Re: School Sisters of Notre Dame Redevelopment Final Submittal

School Sisters of Notre Dame Redevelopment Submission

August 11, 2021

BUILDING BOARD PUNCH LIST ITEM 1

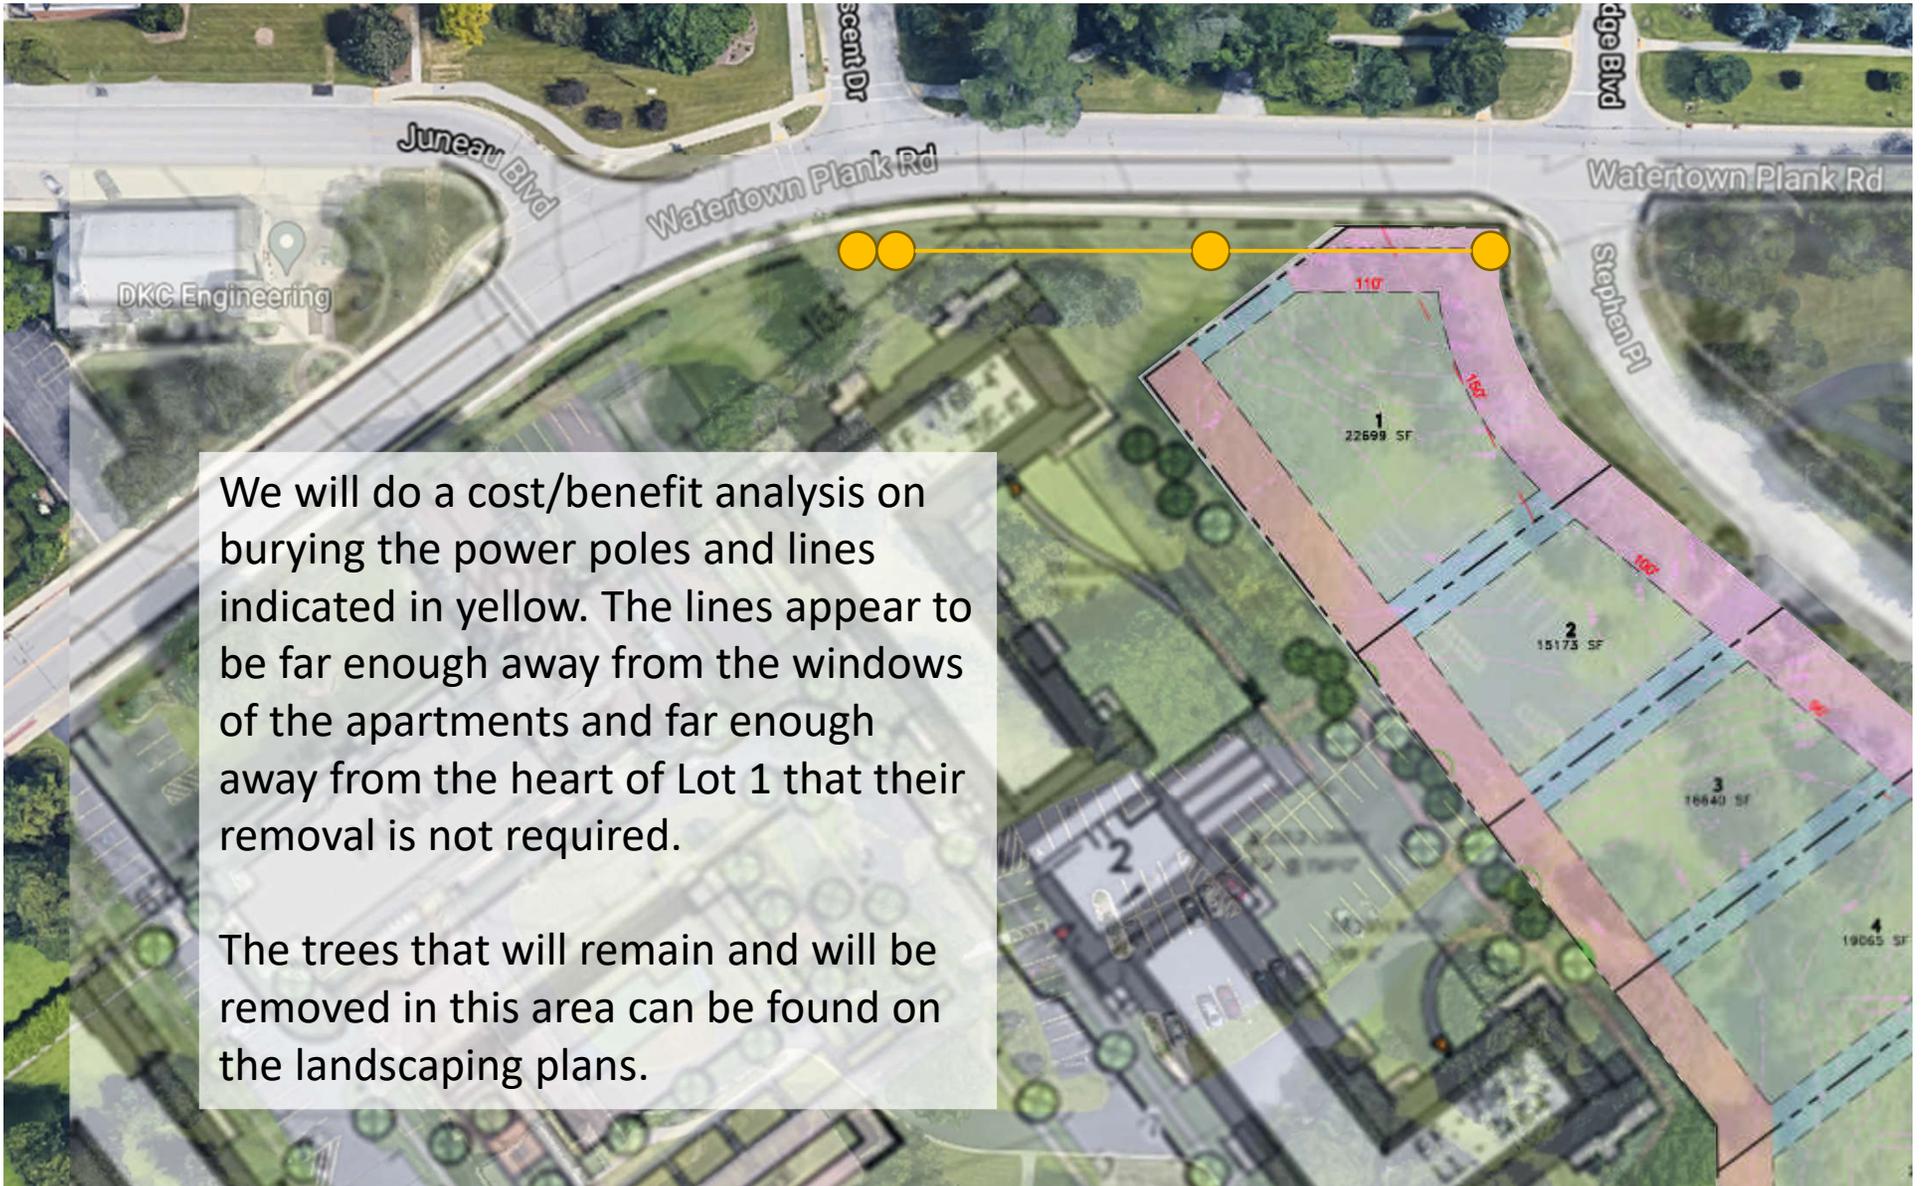
1. Additional clarification as it related to the existing, and proposed new trees and existing power poles on Watertown Plank Road.
2. Additional clarification and detail related to the proposed balcony railings on the backside of Maria and Notre Dame Hall.

We will do a cost/benefit analysis on burying the power poles and lines indicated in yellow. The lines appear to be far enough away from the windows of the apartments and far enough away from the heart of Lot 1 that their removal is not required.

The trees that will remain and will be removed in this area can be found on the landscaping plans.

BUILDING BOARD PUNCH LIST ITEM 8

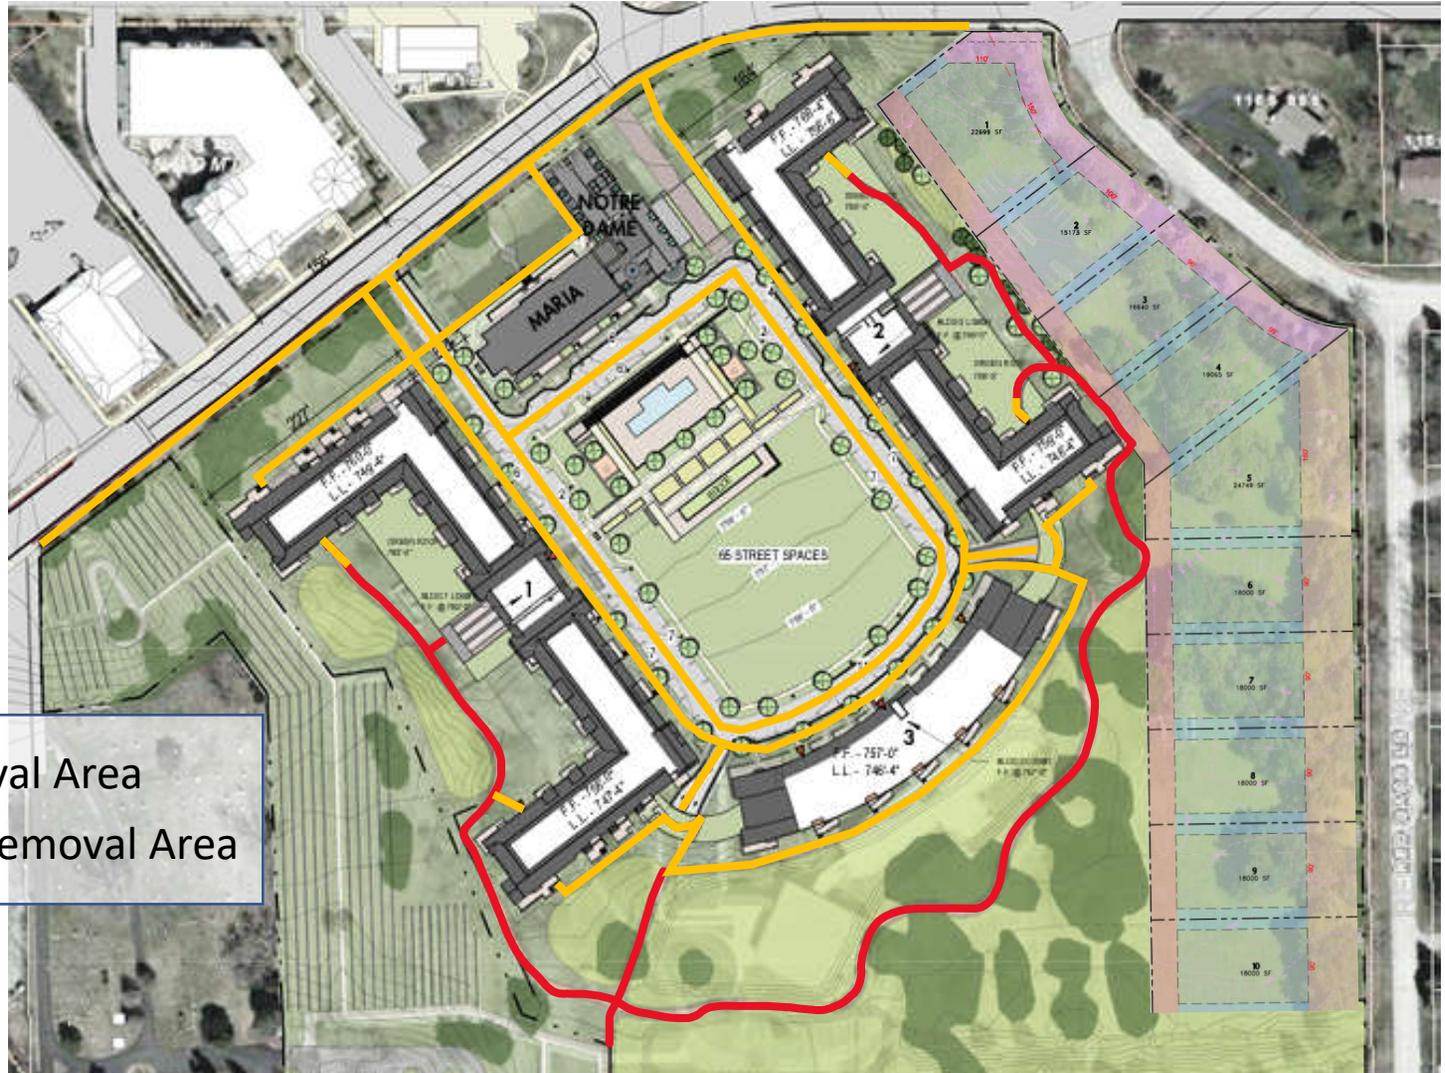
7. Detail relating to the gate to be located at the entrance of the emergency access lane on the east side of Notre Dame Hall.
8. Detail of the proposed patio flooring materials.

WALK-UP UNIT PATIOS - COLORED CONCRETE W/ SCORING
